AMENDMENTS TO THE DRAWINGS

- REMARKS -

The application has been amended in accordance with the Notice of Draftsperson's Patent Drawing Review, dated February 9, 2006. More particularly, the modifications requested to figures 1, 2, and 5 have been made.

FIGURE 1

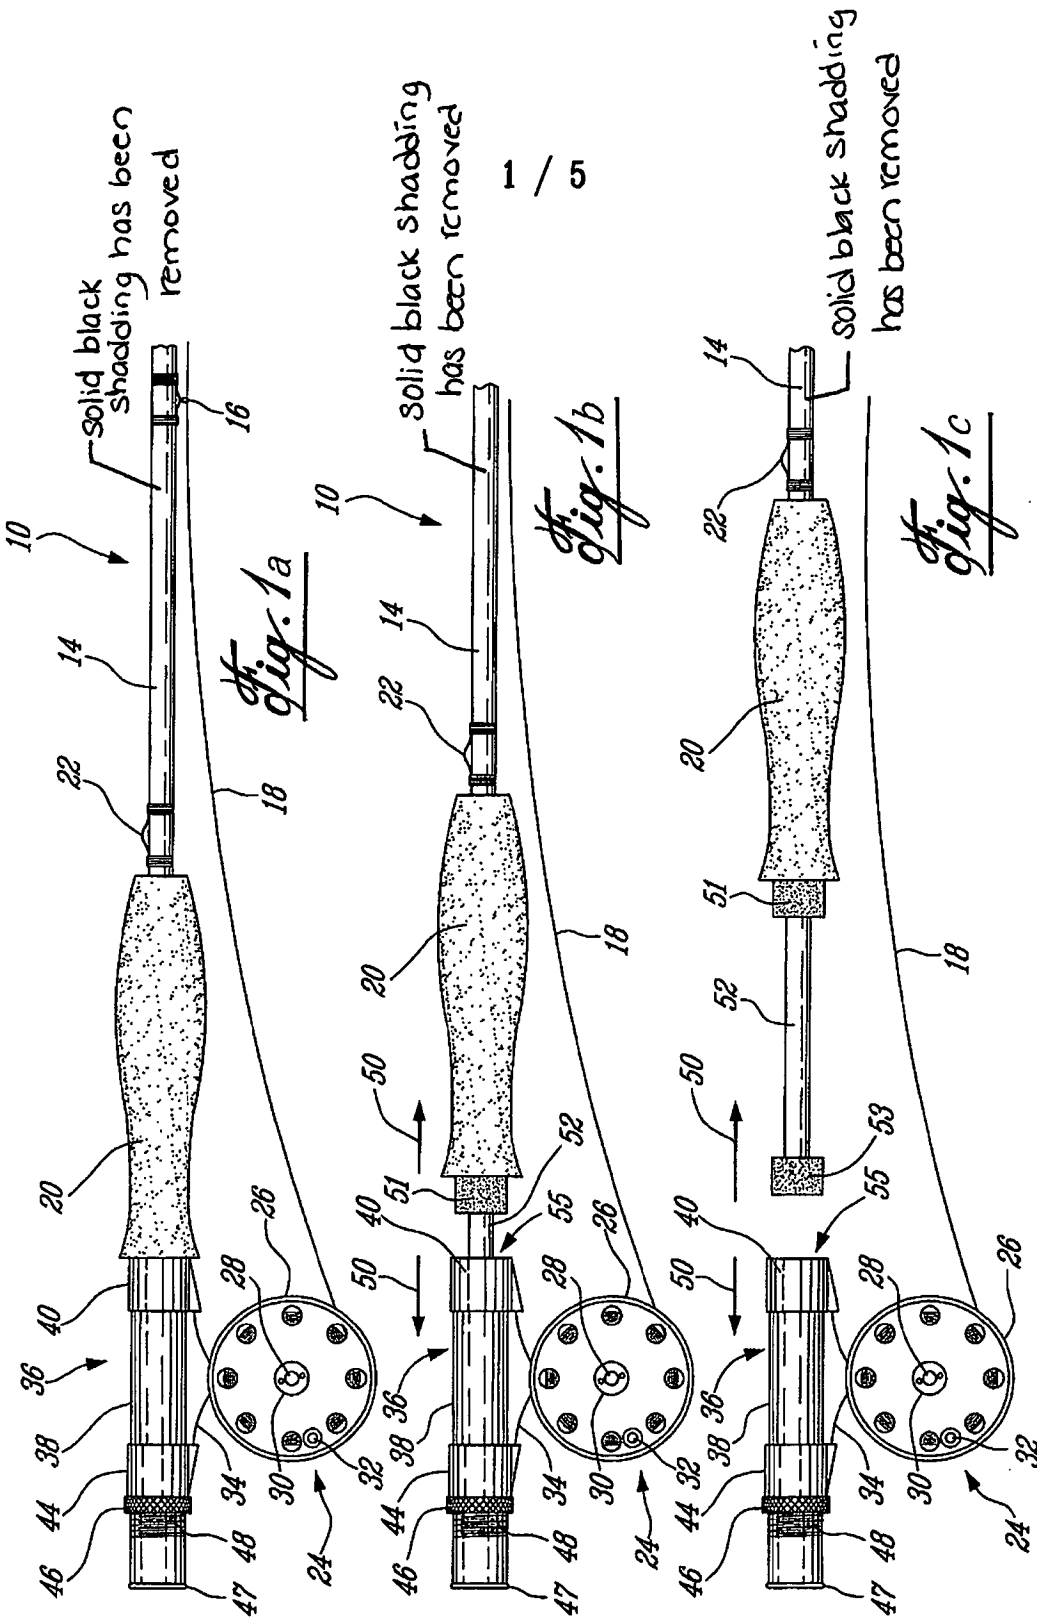
In figure 1, the solid black shading in the rod 14 has been removed.

The figures 1, 2, 4, and 5 have been renumbered Fig. 1a, Fig. 1b, Fig. 1c, Fig. 2a, Fig. 2b, Fig. 4a, Fig. 4b, Fig. 5a, Fig. 5b, and Fig. 5c respectively.

Fig. 3

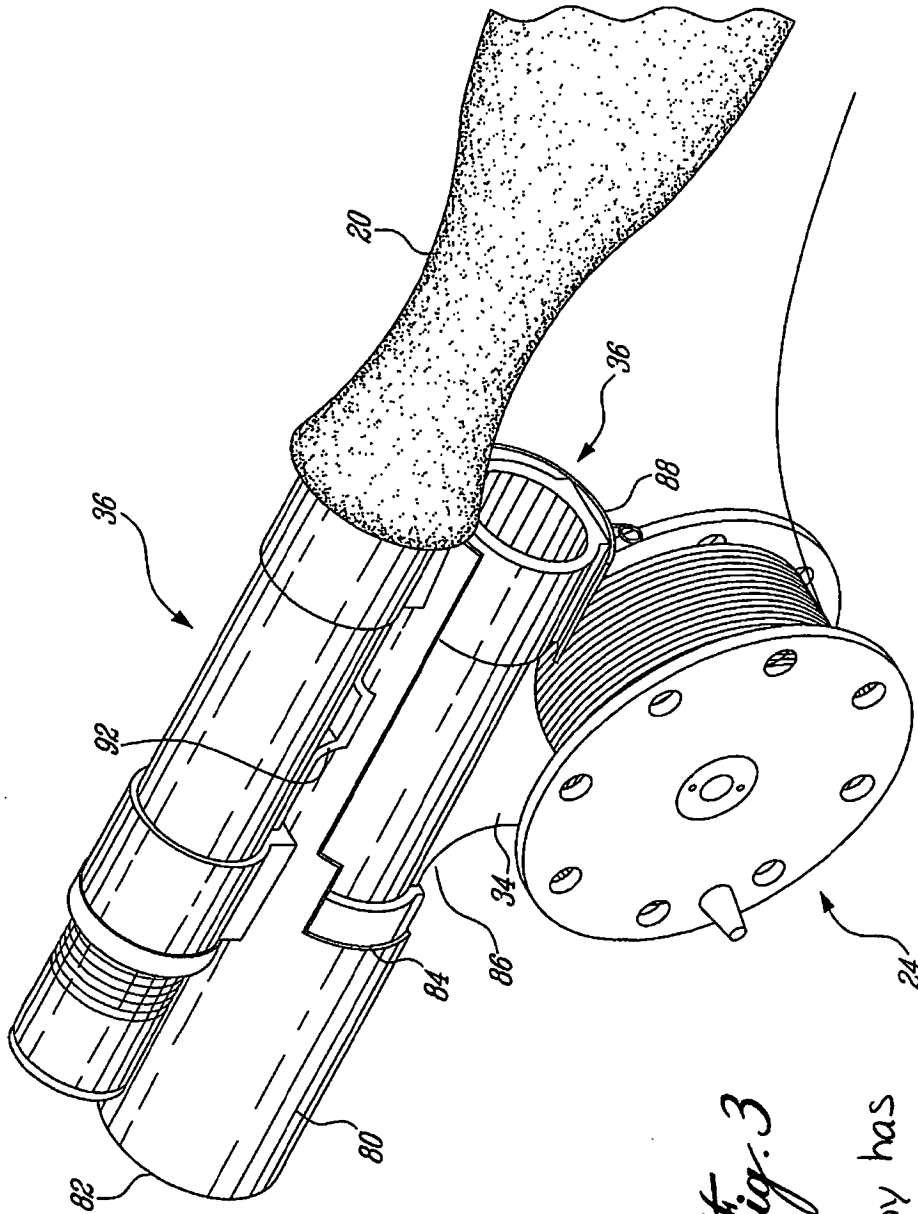
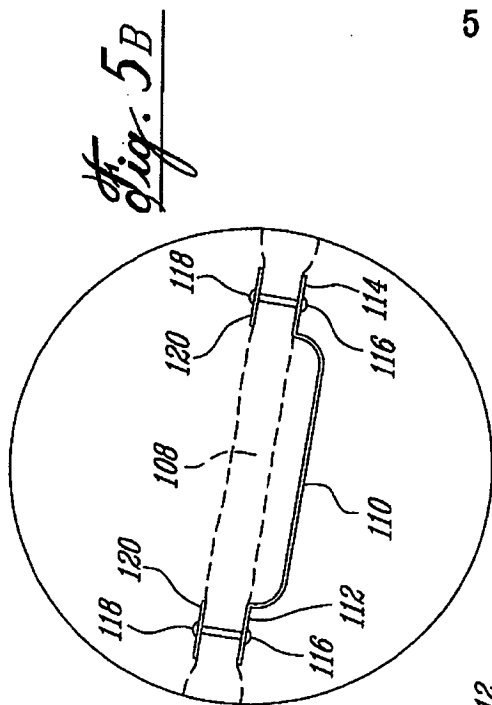
In figure 3, the calligraphy has been modified to correspond to the calligraphy of new figures 1, 2, 4 and 5.

Calligraphy has
been modified
